RE: SD-2021-001/ENG-2021-019/SEPA-2021-010

City of Mukilteo completed a review of your application and the supporting documents provided for a 7-lot subdivision located at 9110 53rd Avenue W, Mukilteo, Washington on April 21, 2023. Based on our review, the following revisions or additional information are necessary to complete our review of your project. If any of the items below are unclear to you, please do not hesitate to contact me right away so I can clarify them for you.

City of Mukilteo - Harbor Grove Submittal Package Review Comments-02

Re: Harbor Grove Resubmittal Package Review Comments

SHEET NAME:
UT-01

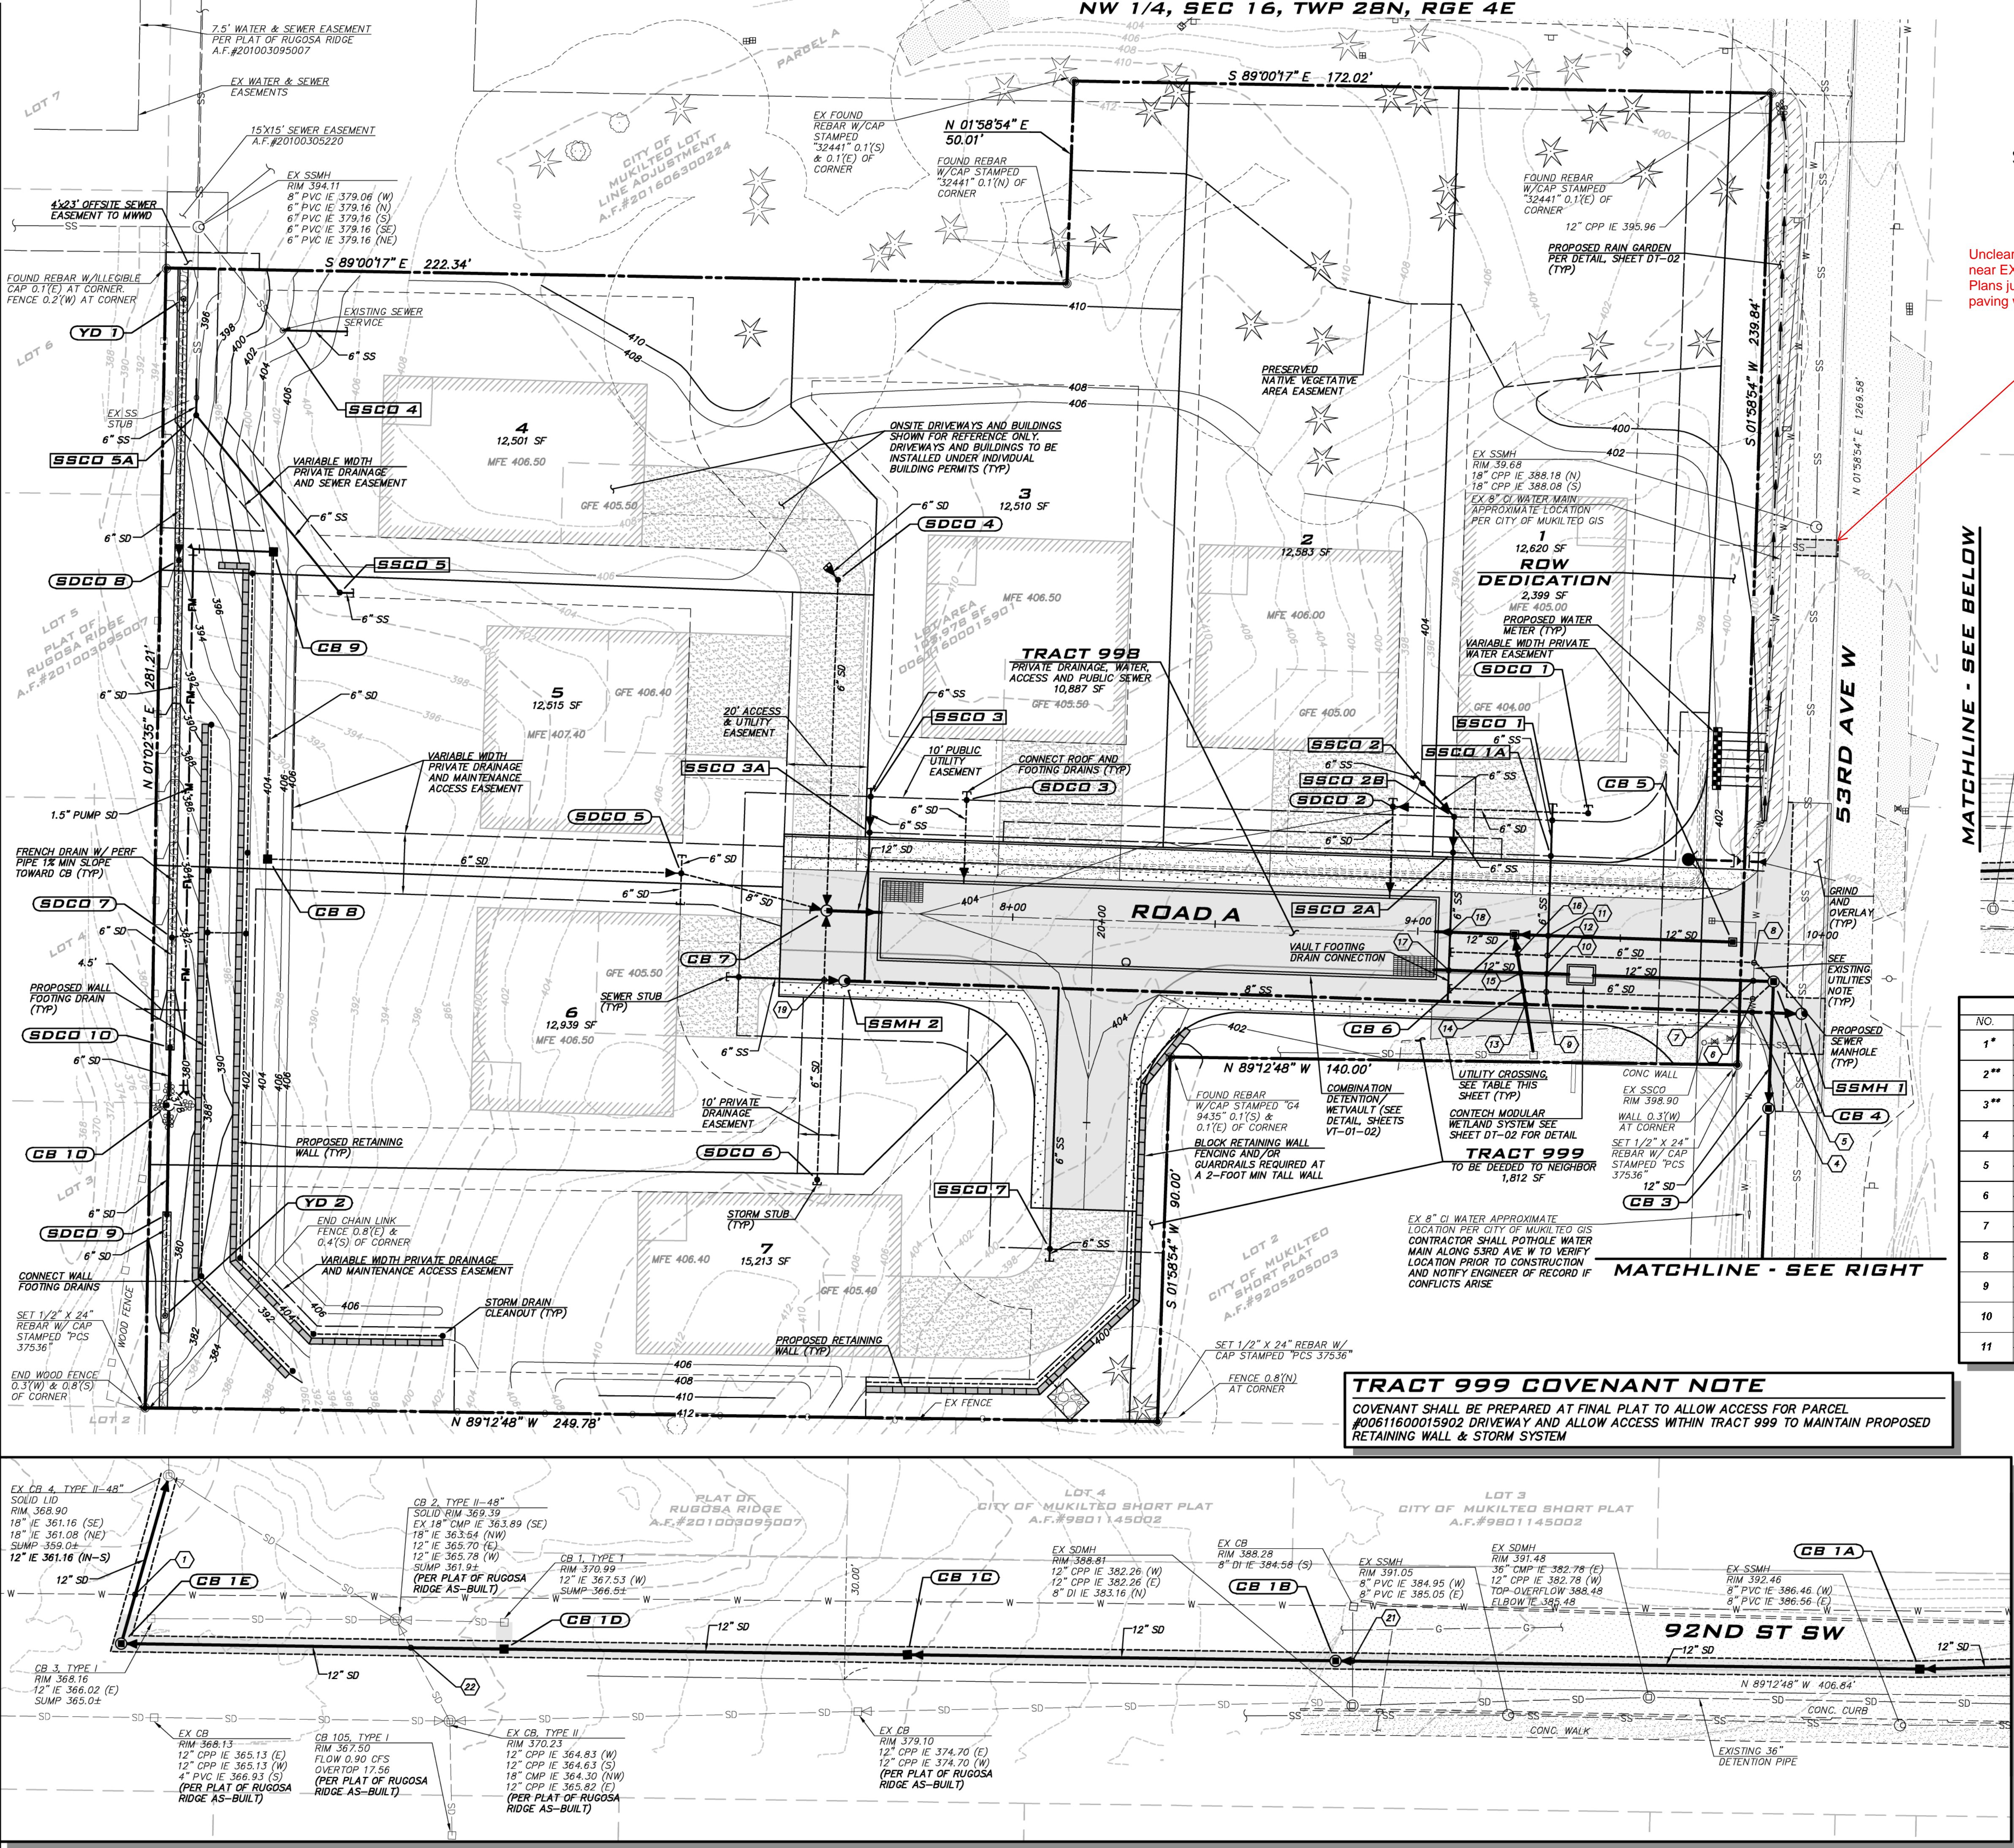
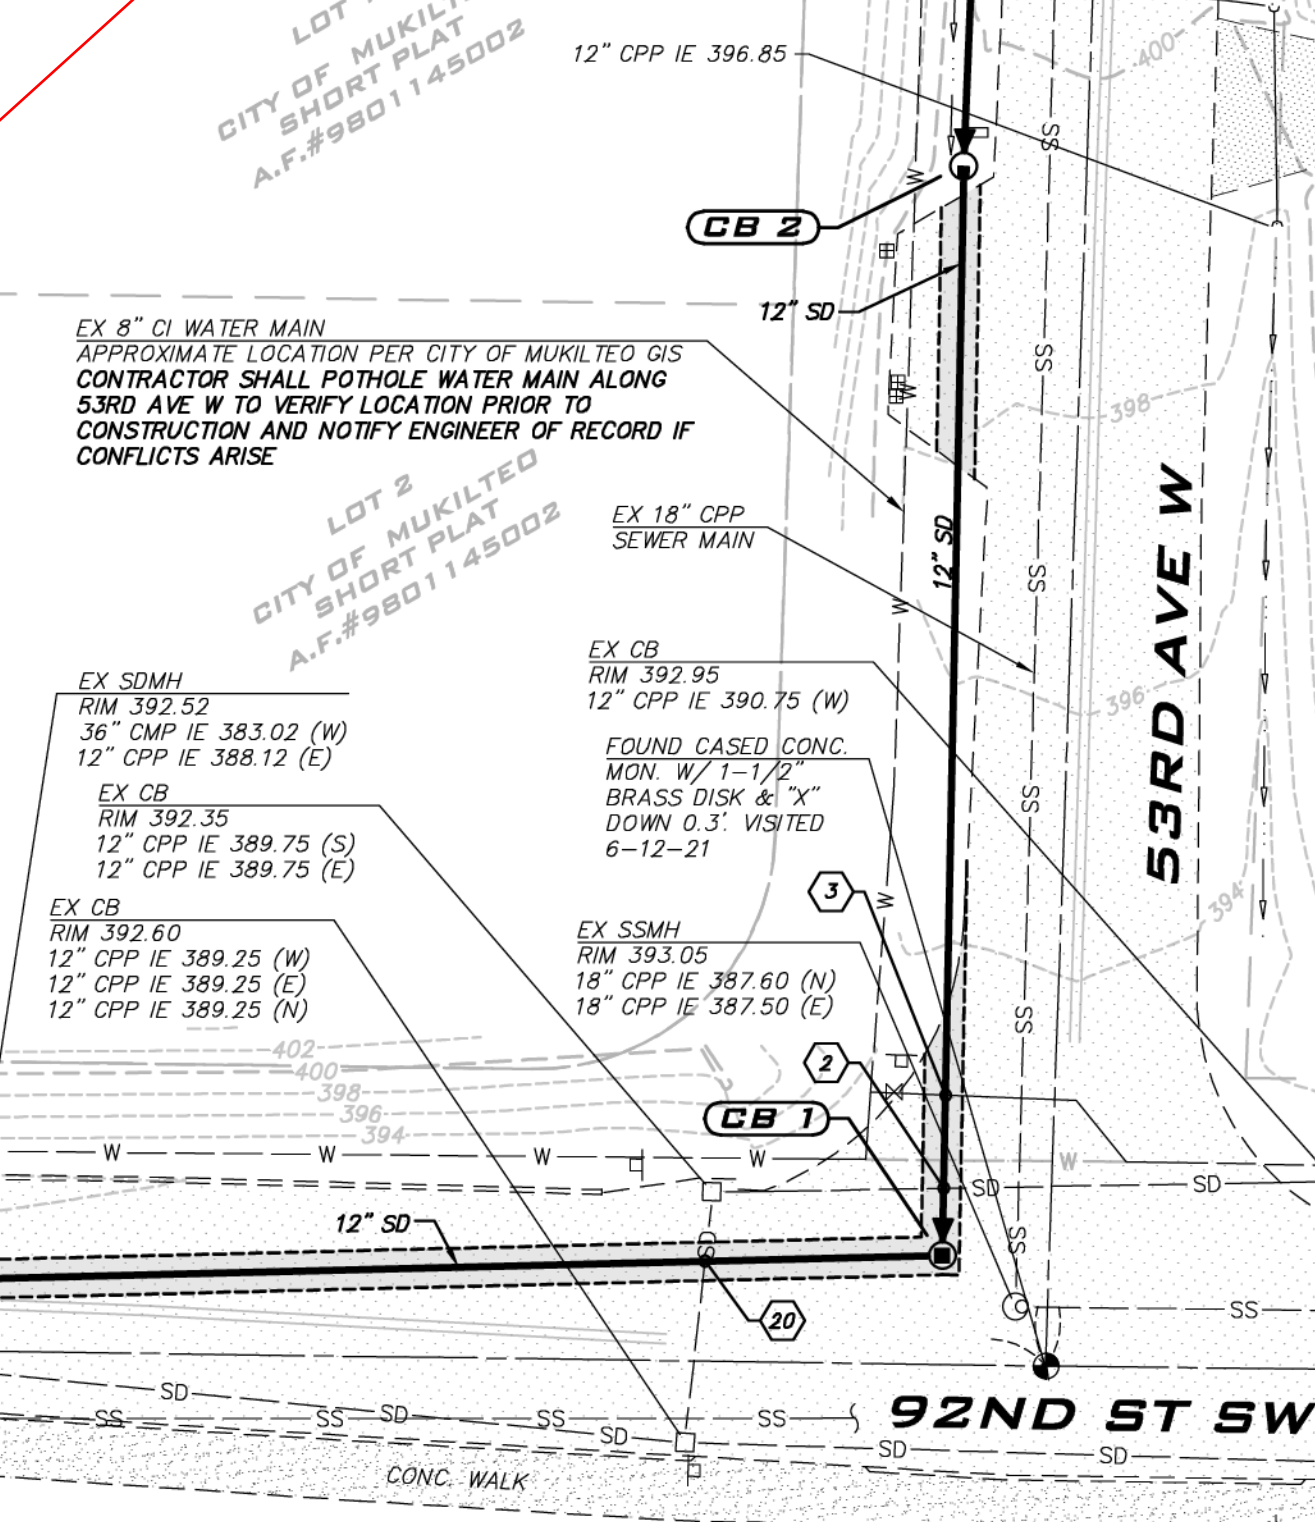
Unclear what work is being done near EX SSMH along 53rd Ave W. Plans just show sawcutting and paving without other callouts.

4/19/23
JOB NUMBER:
21-073
SHEET NAME:
SP-01

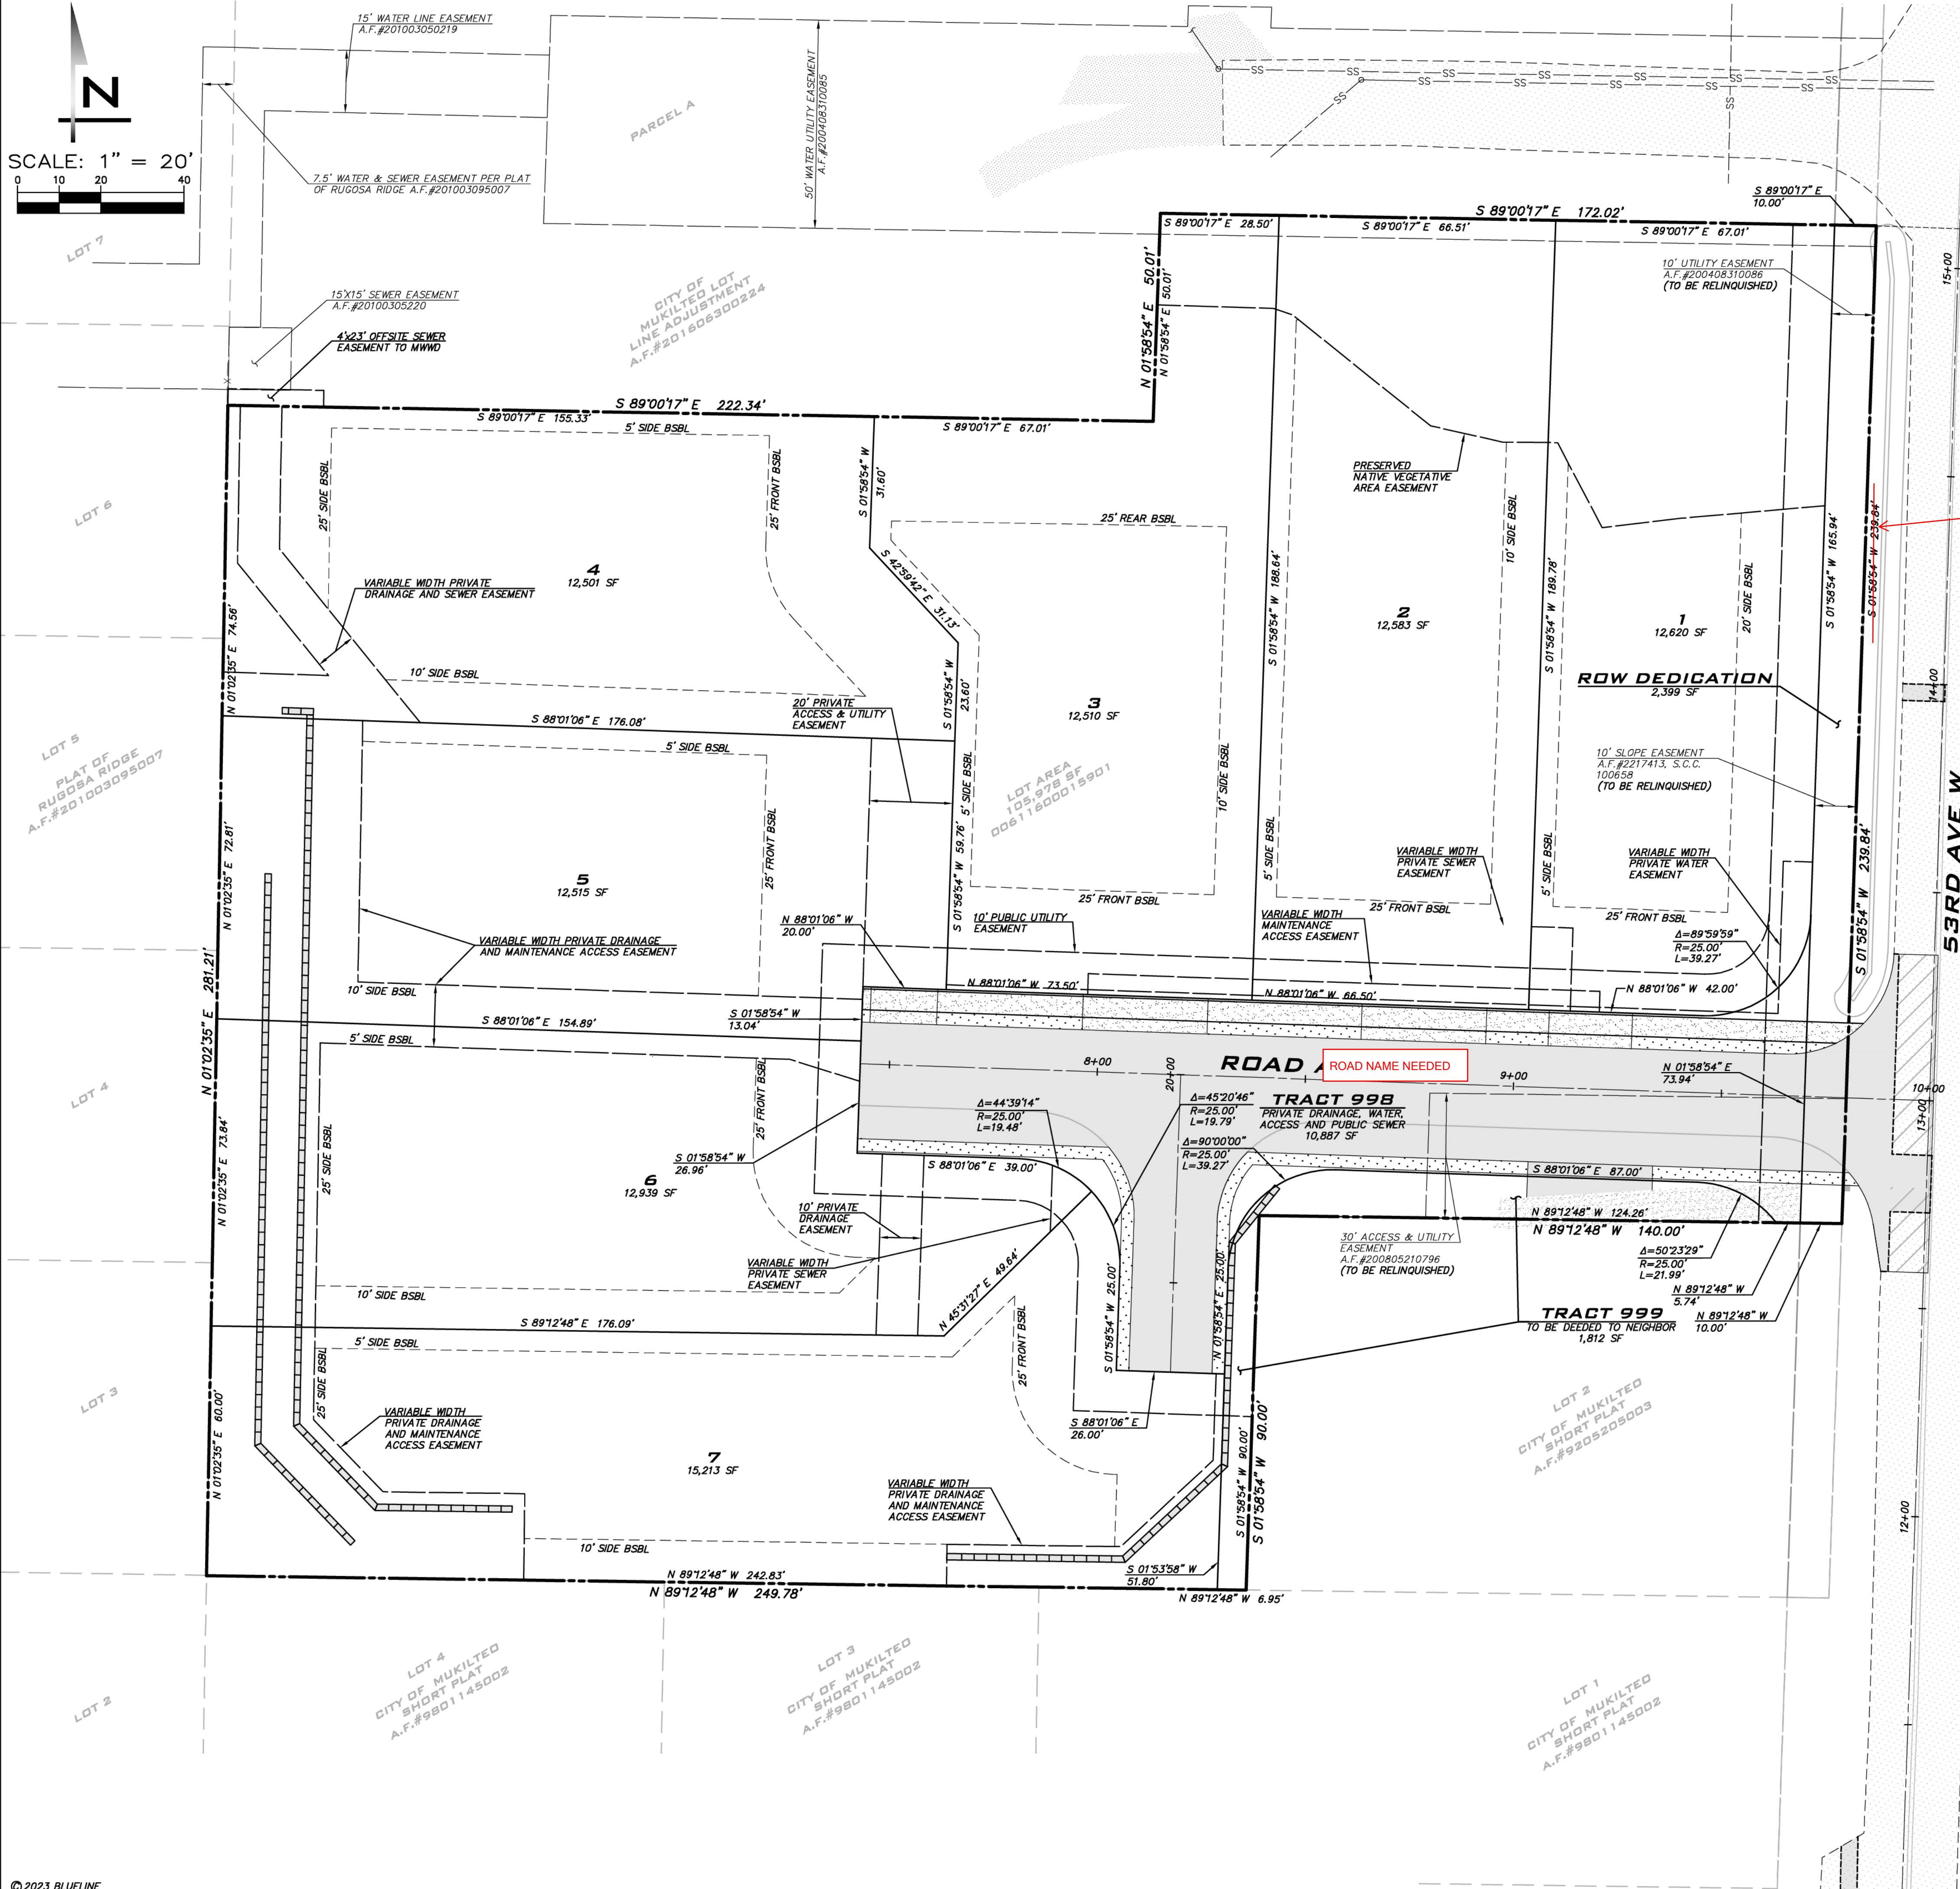
4. Tract 999 does not meet the definition of open space. The applicant is proposing deeding 1,812 square feet to neighbor. It is unclear from the drawings the boundary of Tract 999 to be deeded; however, it appears to follow an existing driveway. City should review this to determine the proposed deeding is acceptable.

The applicant is proposing deeding a portion of the plat to the adjacent/neighboring property, and the City needs to review and ensure this deeding is acceptable. I recommend the City staff review the proposed deeding and ensure it is acceptable if the City has not already done so.

TRACT 999 COVENANT NOTE

COVENANT SHALL BE PREPARED AT FINAL PLAT TO ALLOW ACCESS FOR PARCEL #00611600015902 DRIVEWAY AND ALLOW ACCESS WITHIN TRACT 999 TO MAINTAIN PROPOSED RETAINING WALL & STORM SYSTEM
